1 REDLINE REVISION
February 9, 2005

MARYLAND DOT - STATE HIGHWAY ADMINISTRATION
Office of Traffic & Safety
TRAFFIC ENGINEERING DESIGN DIVISION
(Traffic Signal Plan)
MD 586 (Veirs Mill Road at Wheaton Plaza South Entrance/WMATA

DRAWN BY: Carlos Buitrago	F.A.P. NO. N/A	TS NO. 2440-C	SHEET NO.
CHECKED BY: Farshad Bigdeli	S.H.A. NO.		
SCALE: 1" - 20'	COUNTY: Montgomery	T.I.M.S. NO. G-383	7 OF 8
DATE: May 6, 1988	LOG MILE: 15058605.67

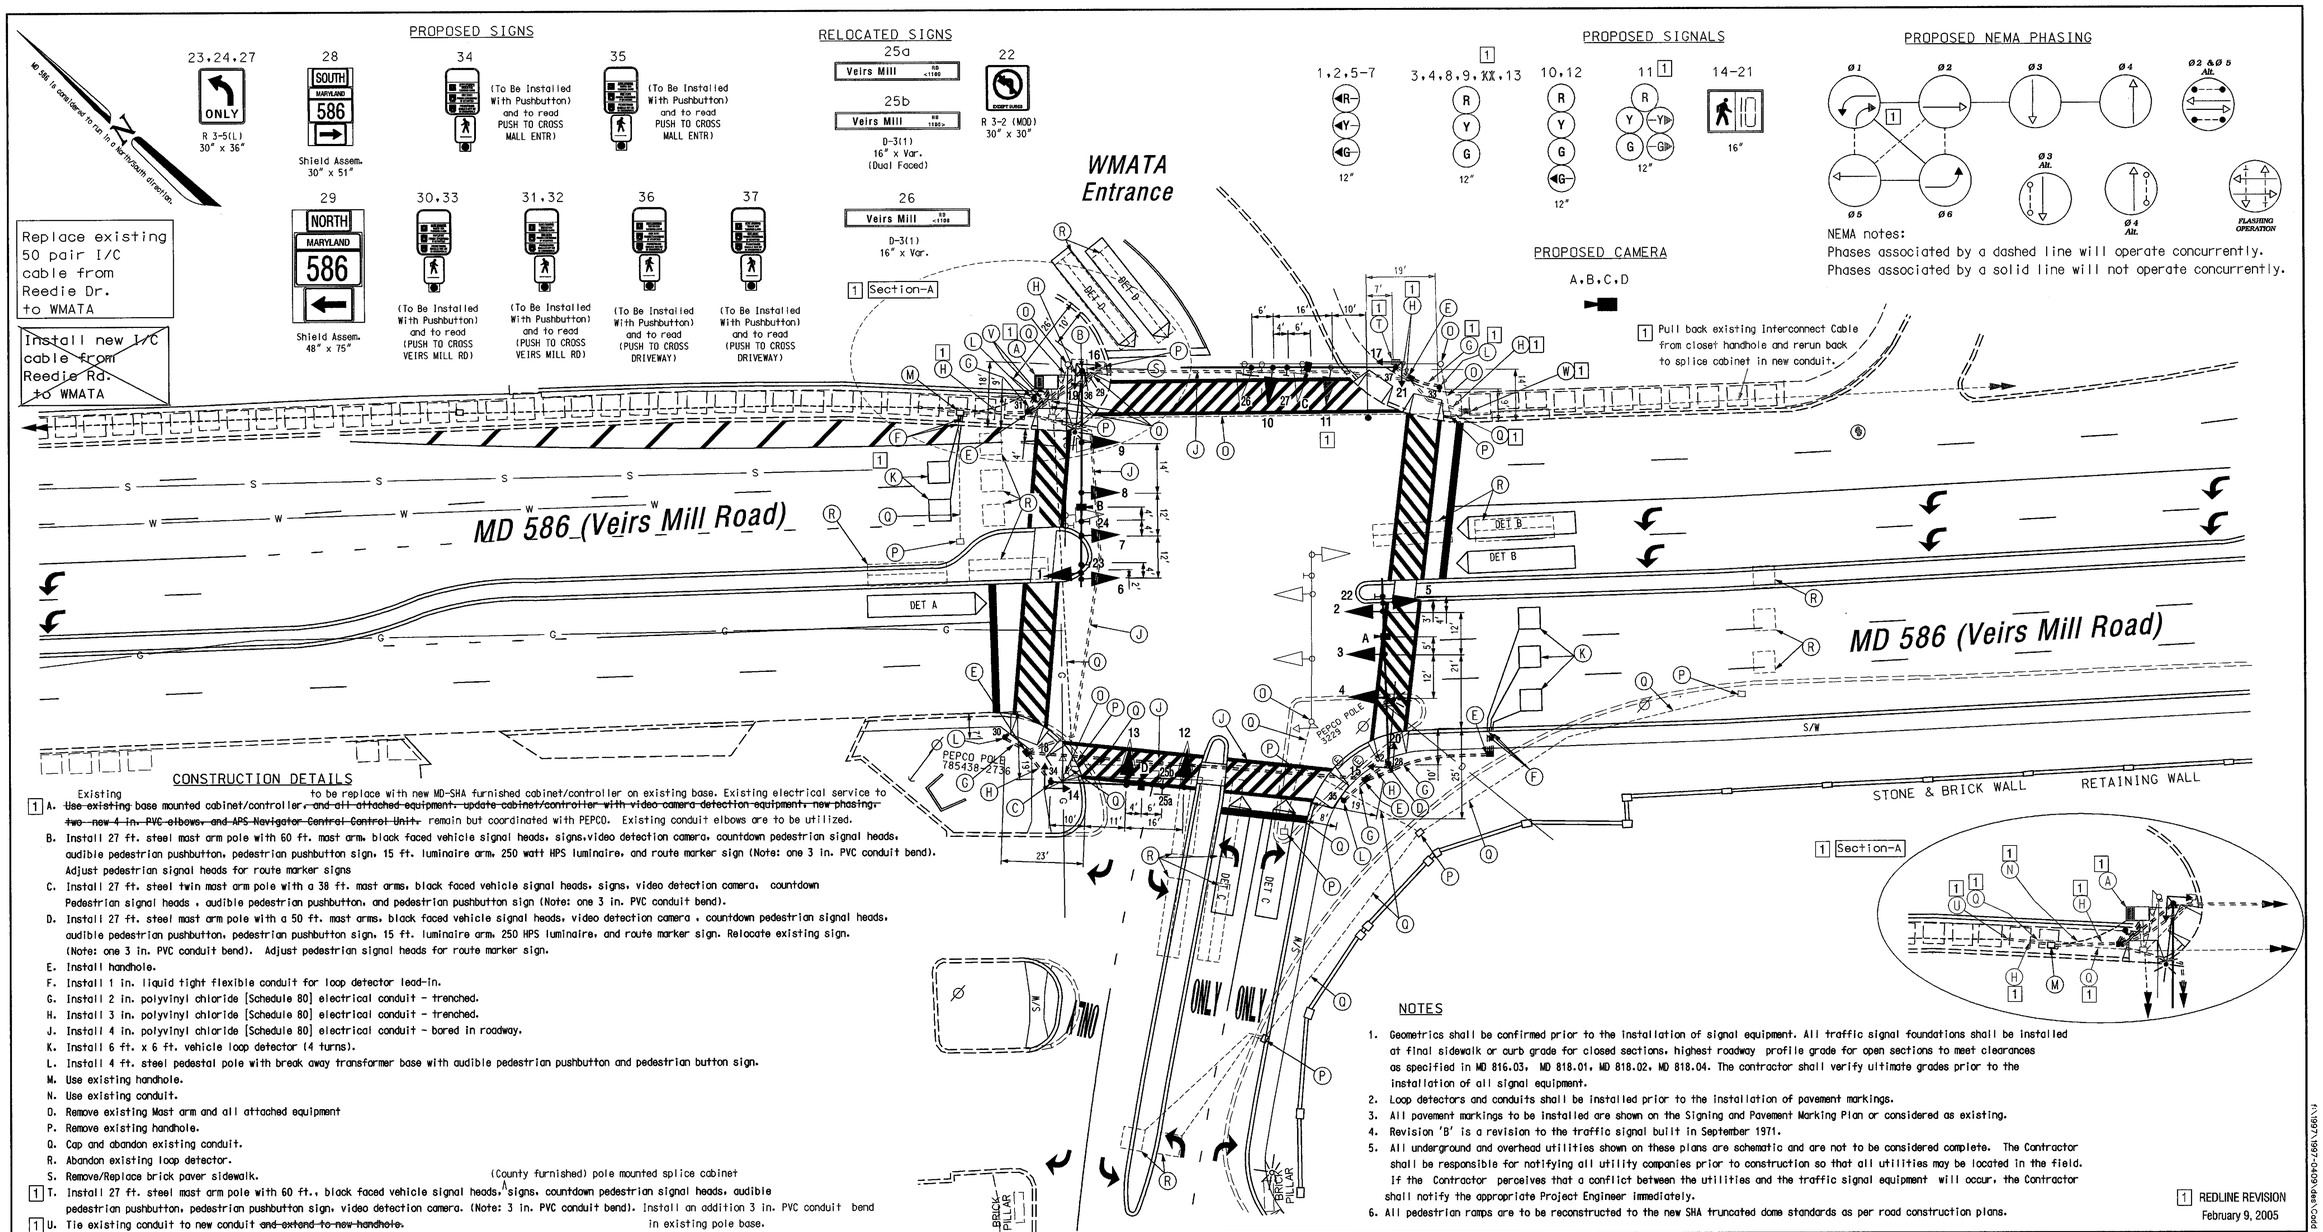
1 A. Existing ~~Use existing~~ base mounted cabinet/controller to be replace with new MD-SHA furnished cabinet/controller on existing base. Existing electrical service to ~~and all attached equipment. update cabinet/controller with video camera detection equipment; new phasing; two new 4 in. PVC elbows, and APS Navigator Control Control Unit.~~ remain but coordinated with PEPCO. Existing conduit elbows are to be utilized.

1 T. Install 27 ft. steel mast arm pole with 60 ft., black faced vehicle signal heads, signs, countdown pedestrian signal heads, audible pedestrian pushbutton, pedestrian pushbutton sign, video detection camera. (Note: 3 in. PVC conduit bend). Install an addition 3 in. PVC conduit bend in existing pole base.

1 U. Tie existing conduit to new conduit ~~and extend to new handhole.~~ (County furnished) pole mounted splice cabinet

1 W. Install handhole on existing conduit run after pulling back existing I/C cable from closest handhole.
